Title of Change:	u8FL Wetttable Flank (WF) using Dummy Tie Bar Approach, with inhouse electroplating process for Automotive Mosfet Devices
Proposed Changed Material First Ship Date:	14 June 2020
Current Material Last Order Date:	20 January 2020 Orders received after the Current Material Last Order Date expiration are to be considered as orders for new changed material as described in this PCN. Orders for current (unchanged) material after this date will be per mutual agreement and current material inventory availability.
Current Material Last Delivery Date:	19 May 2020 The Current Material Last Delivery Date may be subject to change based on build and depletion of the current (unchanged) material inventory.
Product Category:	Active components – Discrete components
Contact information:	Contact your local ON Semiconductor Sales Office or <HM.Ler@onsemi.com>
Samples:	Contact your local ON Semiconductor Sales Office to place sample order or <PCN.samples@onsemi.com> Sample requests are to be submitted no later than 45 days after publication of this change notification.

文書番号# : FPCN22672Z

発行日 : 14 June 2019

Description and Purpose:

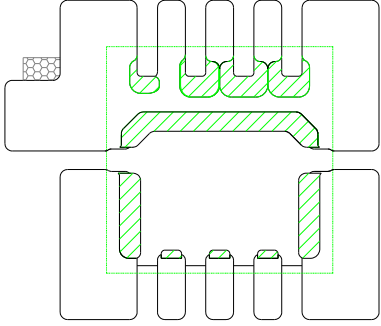
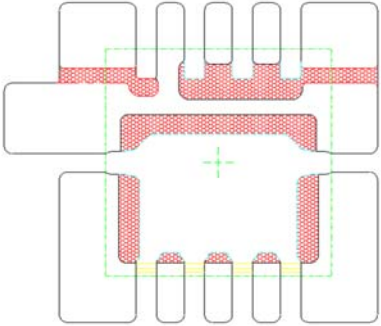
Before Change Description	After Change Description
Leadframe Supplier	MSHE (Malaysia)	Kang Qiang(China)
Leadframe Process	Stamp	Etch
Leadframe Design	<ol style="list-style-type: none"> 1. No tie bar connect to the gate and source lead 2. Chamfer flag 3. coining area-stamp LF 	<ol style="list-style-type: none"> 1. Additional tie bar connect to gate and source lead 2. Removed chamfer 3. Half etched area. 
Sidewall plating method	Electroless SN plating	Electrolytic SN plating
Wettable Plating Site	Metek (Sub-con)	Seremban (Inhouse)

Reason / Motivation for Change:	Improve the side wall solderability by increasing the side wall plating thickness to 8-10um through changing the side wall plating process from electroless plating process(external) to inhouse electroplating process.	
Anticipated impact on fit, form, function, reliability, product safety or manufacturability	The device has been qualified and validated based on the same Product Specification. The device has successfully passed the qualification tests. Potential impacts can be identified, but due to testing performed by ON Semiconductor in relation to the PCN, associated risks are verified and excluded. No anticipated impacts.	
Sites Affected:	ON Semiconductor Sites: ON Seremban, Malaysia	External Foundry/Subcon Sites: None
Marking of Parts/ Traceability of Change:	There will be no change in the device marking scheme. Affected products will be identified with date code. Clean date code will be advised as requested.

説明および目的:

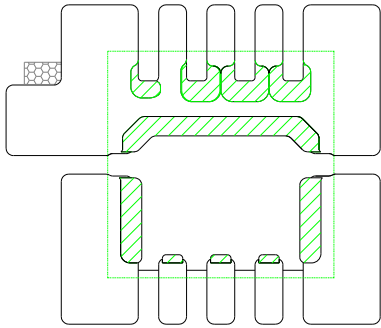
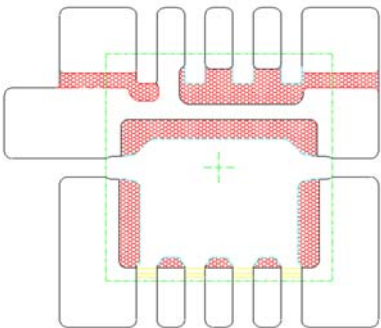
変更される材料	変更前の表記	変更後の表記
リードフレームサプライヤー	MSHE (Malaysia)	Kang Qiang (China)
リードフレームプロセス	スタンピング	エッチング
リードフレーム設計	<ol style="list-style-type: none"> 1. タイバーがゲートとソースリードに接続されていない 2. 面取りフラグ 3. コイニングエリア - スタンプ LF 	<ol style="list-style-type: none"> 1. 追加のタイバーがゲートとソースリードに接続されている 2. 面取りなし 3. 半分のみエッチング 
側面のめっき方法	無電解 SN めっき	電解 SN めっき
ウェットブルめっきサイト	Metek (外注)	Seremban (自社)

変更の理由 / 動機:	側面のめっきプロセスを、外注の無電解めっきプロセスから自社製の電解めっきプロセスに変えることにより、側面のめっきの厚さを 8-10um に増加して、側面のはんだづけ性を向上しました。	
適合性、形状、機能、信頼性、製品安全性、または製造可能性に関して見込まれる影響	<p>デバイスは同じ製品仕様に基づいて認定および検証されています。デバイスは認定試験に正常に合格しています。潜在的な影響が確認される可能性があります。オン・セミコンダクターが PCN に関して実施する検査により、関連するリスクは検証および排除されます。</p> <p>予想される影響はありません。</p>	
影響を受ける拠点:	オン・セミコンダクター拠点: ON Seremban, Malaysia	外部製造工場 / 下請業者拠点: なし
部品の表示 / 変更の追跡可能性:	デバिसマーキングスキームに変更はありません。影響を受ける製品は日付コードで識別します。ご要求に応じて、変更品の日付コードは提供されます。
